Tool & Product Update

Model 917 POWERIG® Hydraulic Unit Return Line Improvement—Steel Tee Replaces Plastic Tee, P/N 504367

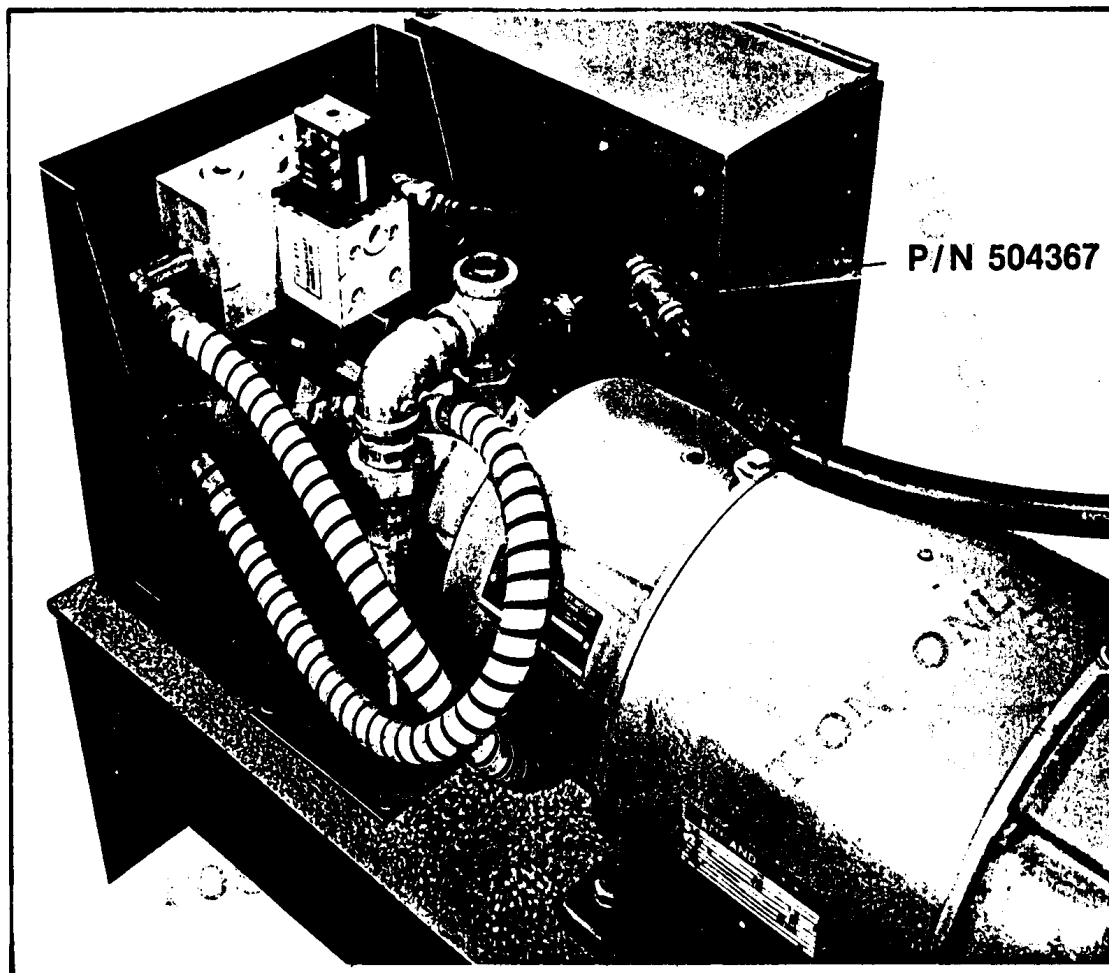
For increased product reliability the Plastic Tee Fitting P/N 504367 has been changed to a steel fitting with the same part number.

Steel Tee Fitting, P/N 504367, can be installed on all Model 917 units now in use.
